SUBJECT: PRAIRIE ISLAND NUCLEAR GENERATING PLANT, UNIT NOS. 1 AND 2 -
ISSUANCE OF AMENDMENTS RE: PRESSURIZER SAFETY VALVES AND MAIN STEAM
SAFETY VALVES LIFT SETTING TOLERANCE CHANGE AND SAFETY LIMIT CURVE
CHANGES (TAC NOS. M92349 AND M92350)

AMENDMENT NO. 123 TO FACILITY OPERATING LICENSE NO. DPR-42-PRAIRIE ISLAND UNIT 1
AMENDMENT NO. 116 TO FACILITY OPERATING LICENSE NO. DPR-60-PRAIRIE ISLAND UNIT 2

Amendment No. 123
License No. DPR-42

Figure TS.2.1-1

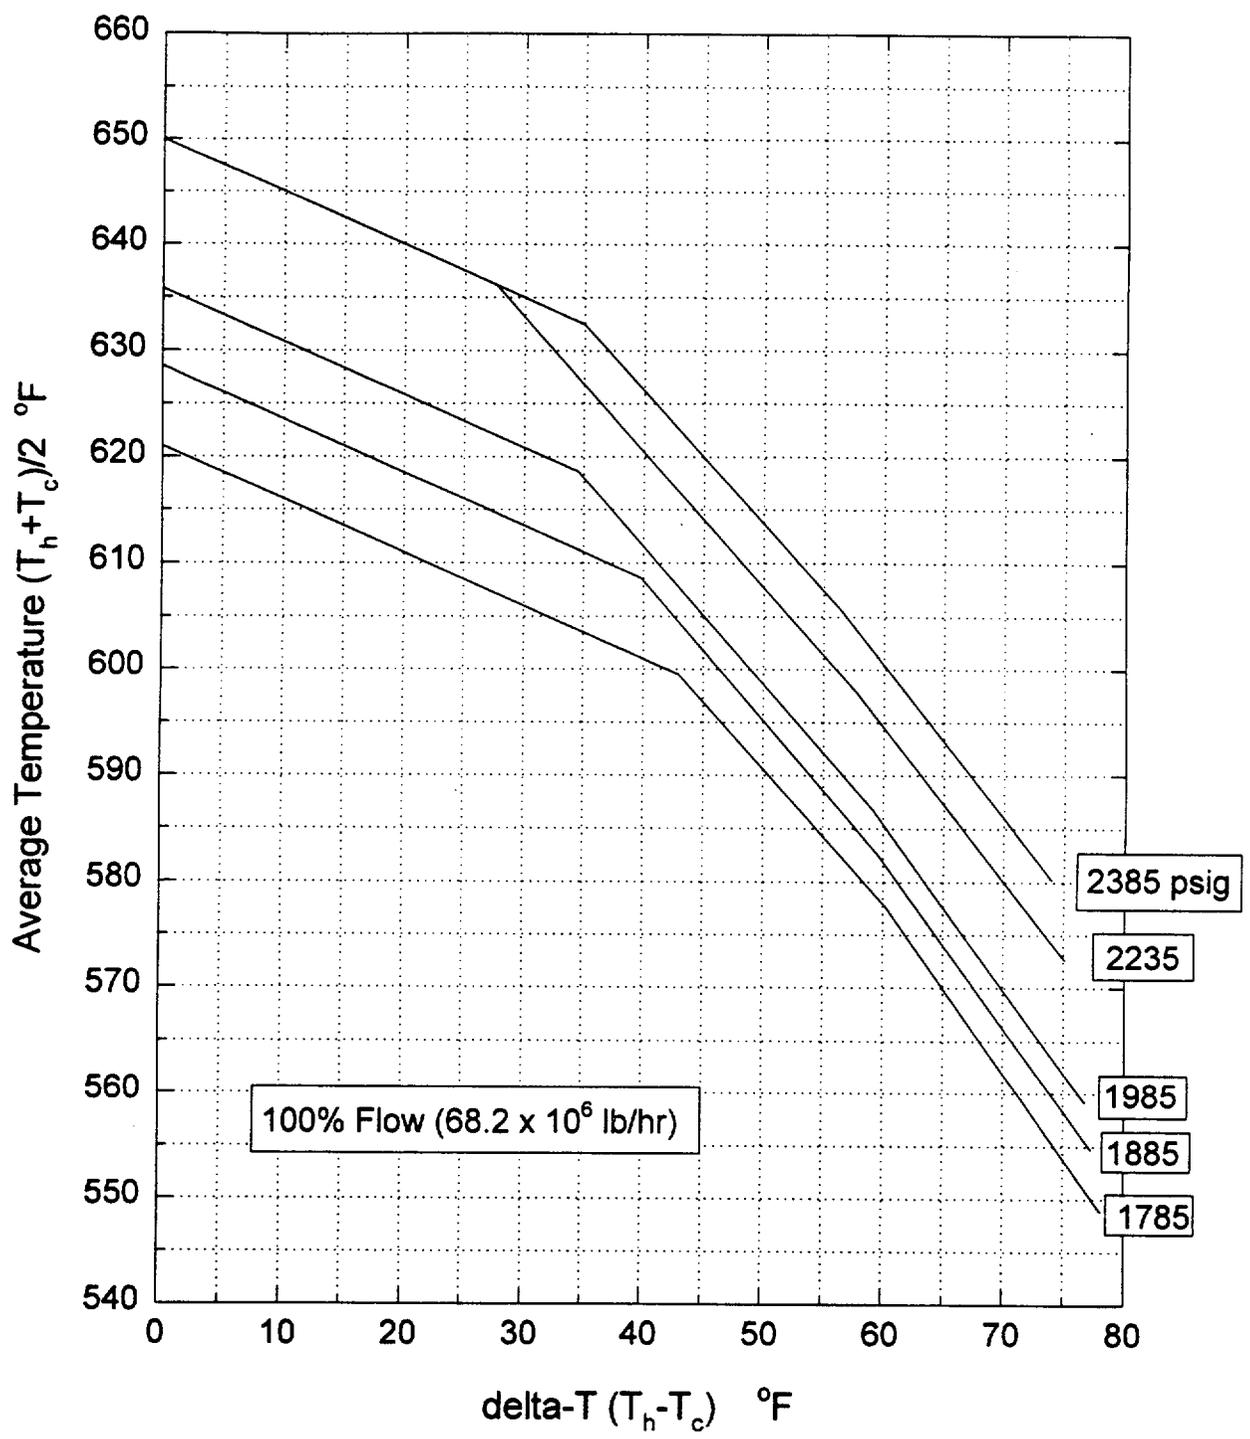
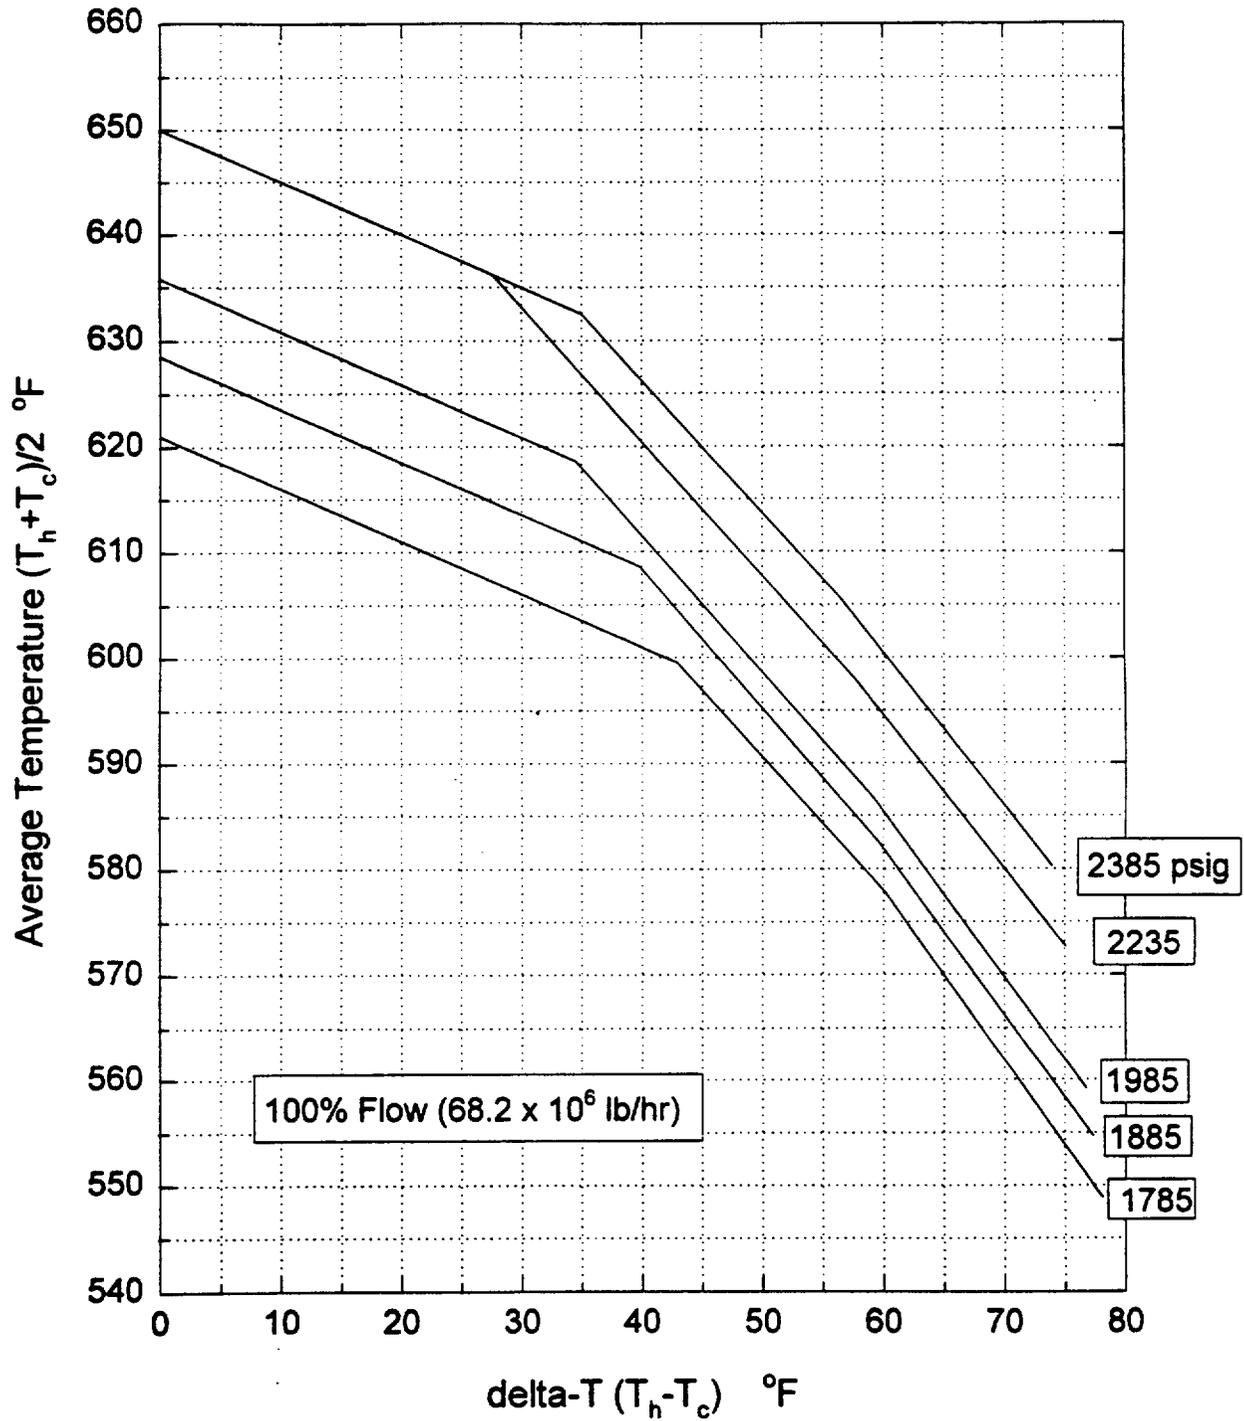
The proposed changes in this area would adjust for the impact of changing the lift setting tolerances for the pressurizer safety valves and MSSVs. The proposed changes would also remove the curve showing the locus of points at which the MSSVs open and lower the DNB limit part of the curves.

As previously stated, TS Figure 2.1-1 defines the regions of acceptable operation with respect to average RCS temperature, reactor thermal power, and RCS pressure for which the minimum DNB ratio is not less than the safety analysis limit (1.30 for Exxon fuel and 1.17 for Westinghouse fuel). The figure also shows the locus of points at which steam generator safety valves open. The licensee has requested removal of the curve showing the locus of points at which the safety valves open. Since this locus curve is not a safety limit but, rather, represents a limiting condition governed by plant equipment which prevents plant operating conditions from approaching the safety limits, the staff concurs with its removal from Figure 2.1-1. Figure B.2.1-1 has instead been incorporated into TS Bases 2.1 along with the ΔT trips and the locus of points where the steam generator safety valves open to demonstrate that the ΔT trips and the steam generator safety valves do protect the reactor from exceeding the safety limits.

The locus of points past the first knee in Figure 2.1-1 for all pressures represents the thermal-hydraulic conditions above which the hot channel has a DNBR less than the limit. The licensee has proposed to lower this portion of the curves because the bypass flow fraction was increased to 6 percent when the fuel thimble plugs were removed, the F_{4H}^N limit was increased to 1.75 with the loss-of-coolant accident (LOCA) analysis performed for Unit 2 Cycle 16, and a rod bow penalty of 2.6 percent was added to the DNB calculation. The staff finds this proposed change acceptable since it was evaluated using approved DNB methodology and provides appropriate safety margins in the curves of Figure 2.1-1.

The licensee has also proposed changing the x-axis of Figure 2.1-1 from "% Rated Core Power" to " $\Delta T(T_h - T_c)$ °F". The staff finds this proposed change acceptable for the following reasons. The full power ΔT is different at different temperatures and pressures because water properties are nonlinear. This makes it difficult to plot the curves at each pressure using the same scale for the percent power axis. In addition, the ΔT trip setpoints which the reactor protection system actually calculates is based on the ΔT , not the percent power. Therefore, the proposed x-axis is a more appropriate variable.

An additional proposed change would remove the curve at 1685 psig and add curves at 1785 and 1885 psig to Figure 2.1-1. Since 1685 psig is a much lower pressure than would ever be achieved in plant operation due to the TS limits of the low pressurizer pressure trip setpoint, its elimination is acceptable.

The addition of the curves at 1785 and 1885 psig ensures that the entire range of pressures allowed by TS 2.3.A.2.c is bounded. This change is, therefore, acceptable.

Origin of Safety Limit Curves at 2235 psig
with delta-T Trips
and Locus of Reactor Conditions at
which the SG Safety Valves Open

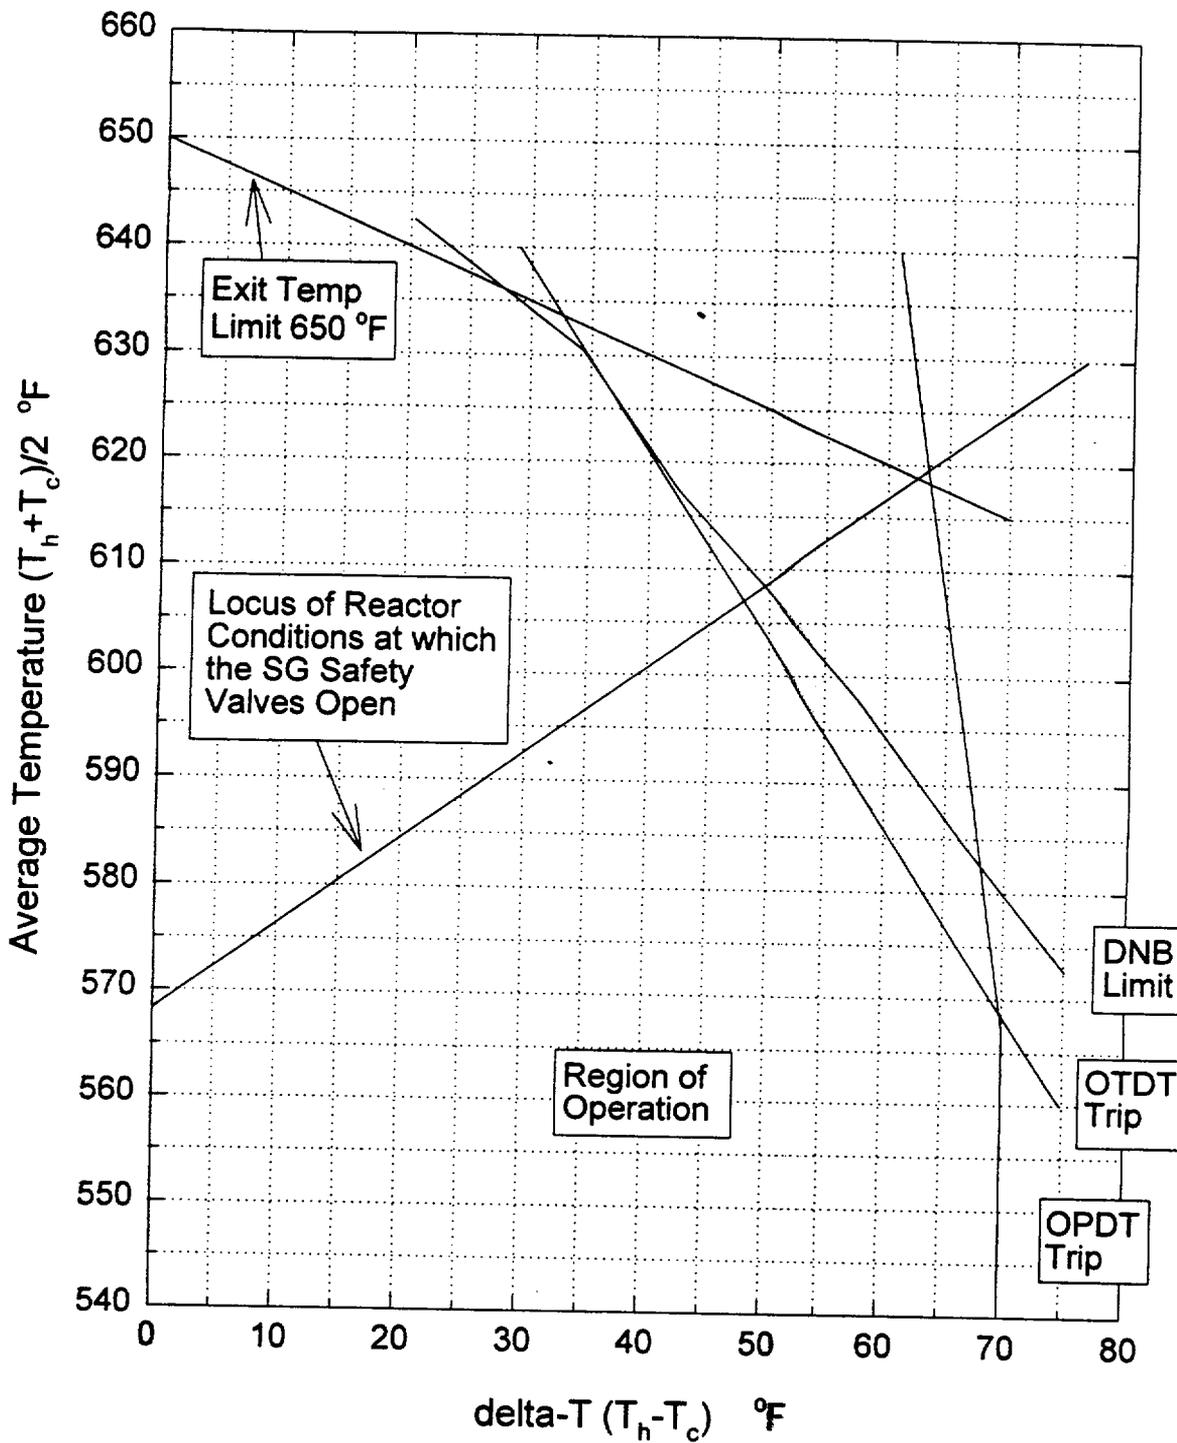
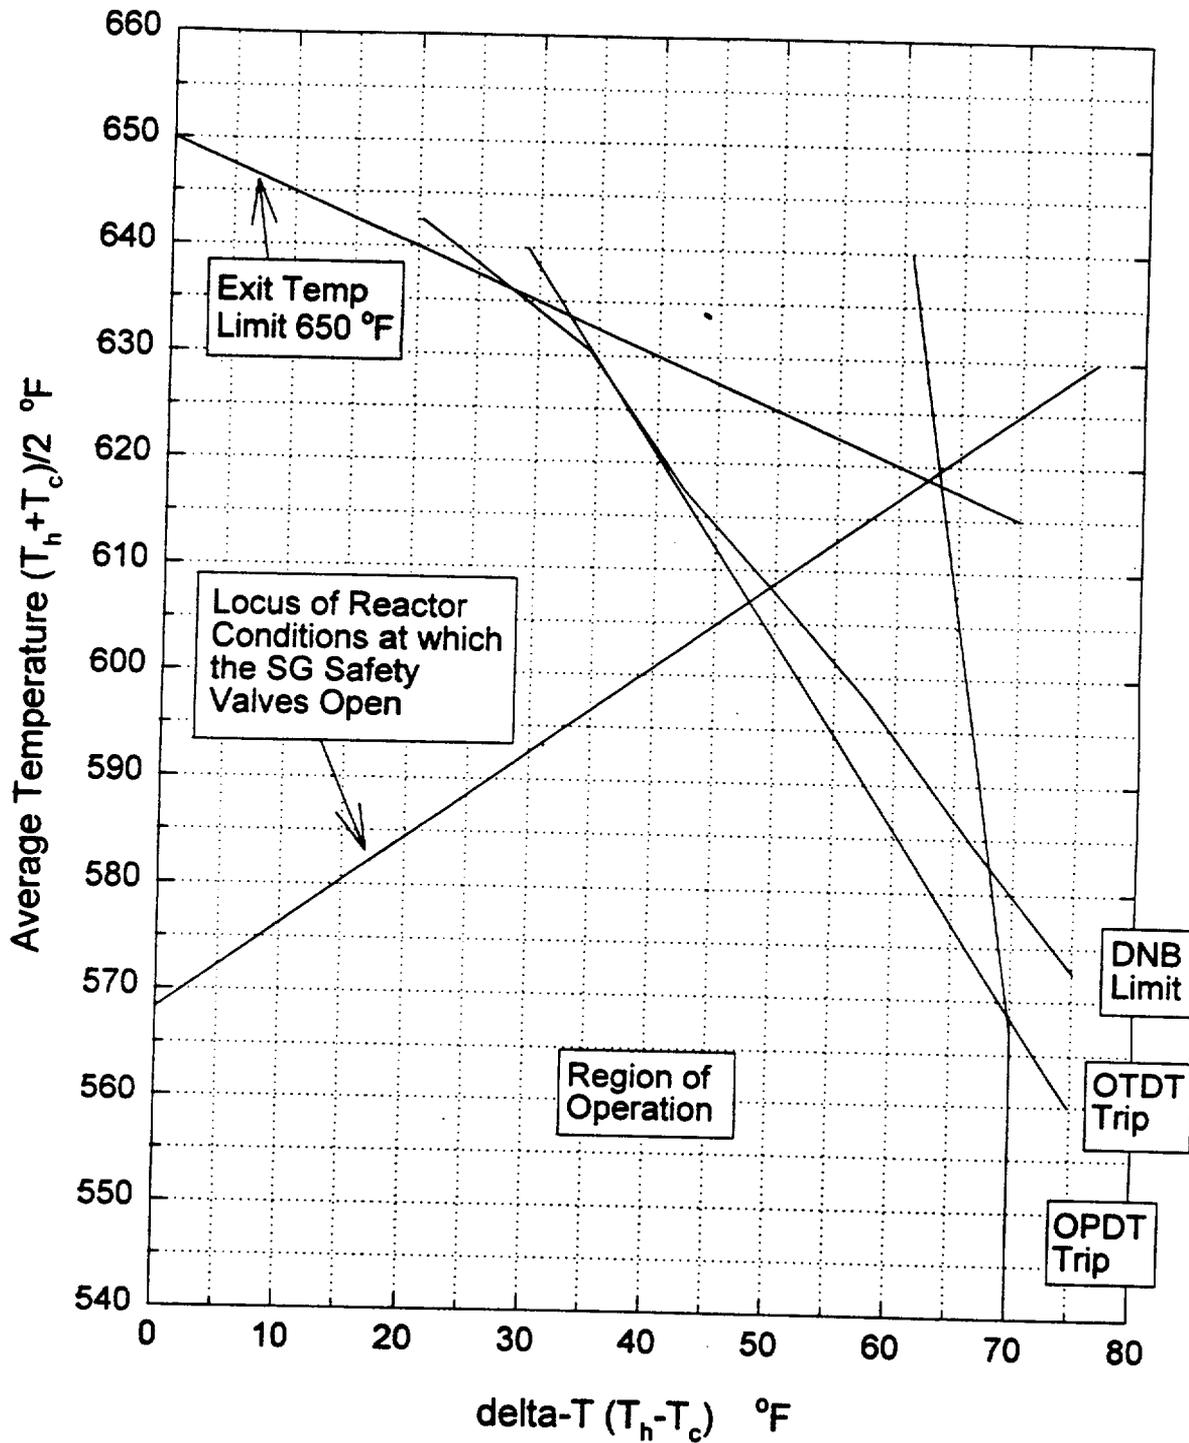
As an example, all the limits for the 2235 psig curve are plotted in Figure B.2.1-1 along with the ΔT trips and the locus of points where the steam generator safety valves open. This plot demonstrates that the ΔT trips and the steam generator safety valves do protect the reactor from exceeding the safety limits. Note, however, that the OTAT trip locus on that plot is for steady state conditions and that the locus will drop in response to the rate at which the ΔT is increasing. In addition, $f(\Delta I)$ increasing will also lower the OTAT trip locus.
